**PREVOST**

**WARRANTY  
BULLETIN**

WB12-18

DATE : AUGUST 2012	SECTION : 23 - Accessories
EXPIRATION: AUGUST 2014	
SUBJECT : AFSS HARNESS MODIFICATION IN FRONT SERVICE COMPARTMENT

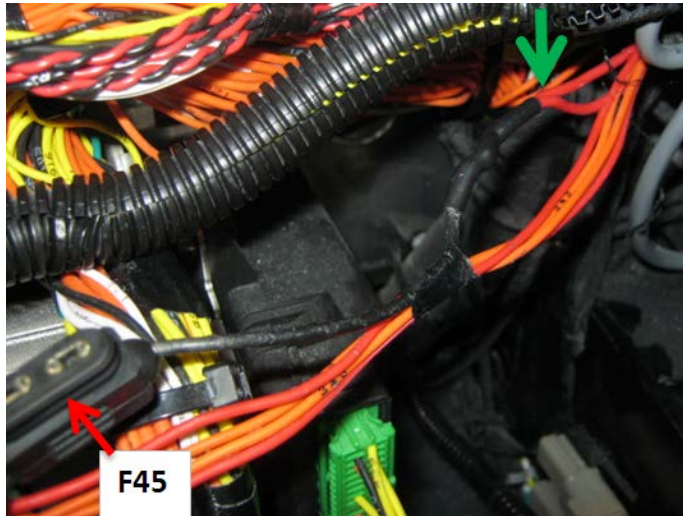
2. Disconnect electrical plug at the extinguisher to prevent any false triggering of the system.

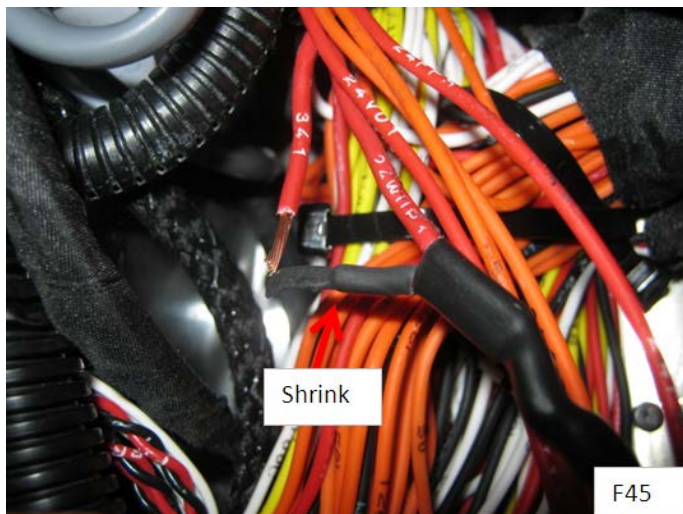
6. Remove electric tape up to splice in harness (Green arrow on photo).

7. Cut wire 341 and slip shrink tube over strand going to F45.

8. Splice a new white wire on the remaining end of wire 341.

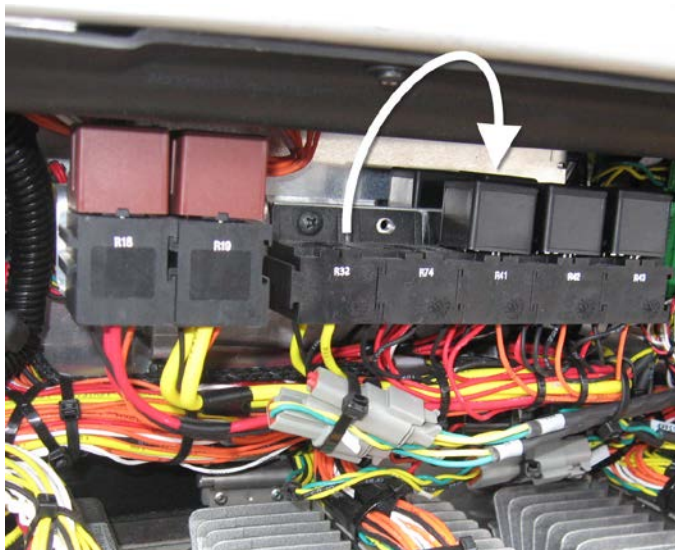
9. Locate R4 relay.

Look behind bracket holding the group of small relays.

In doubt, refer to the panel layout decal inside front service compartment door to locate R4.

10. Route new white wire up to wire 341 on relay R4, pin 86 (Arrow).

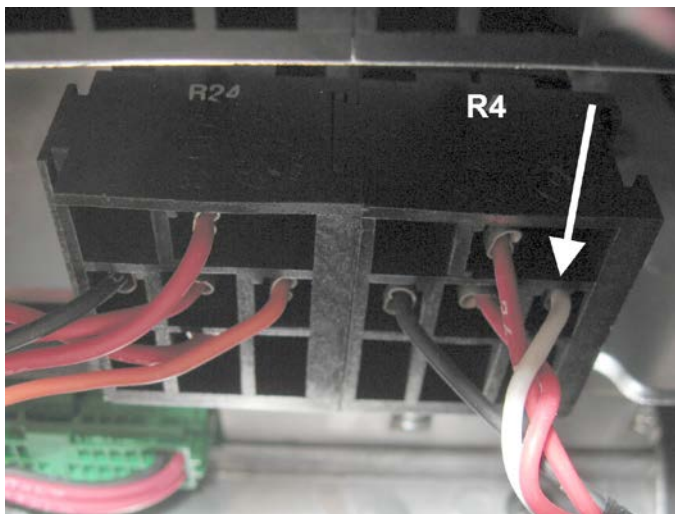
11. Remove wire 341 from relay base.

12. Cut the tab terminal. Strip the wire.

13. Install #561108 new tab terminal and crimp both 341 wires together.

14. Reconnect to pin 86 of R4 relay.
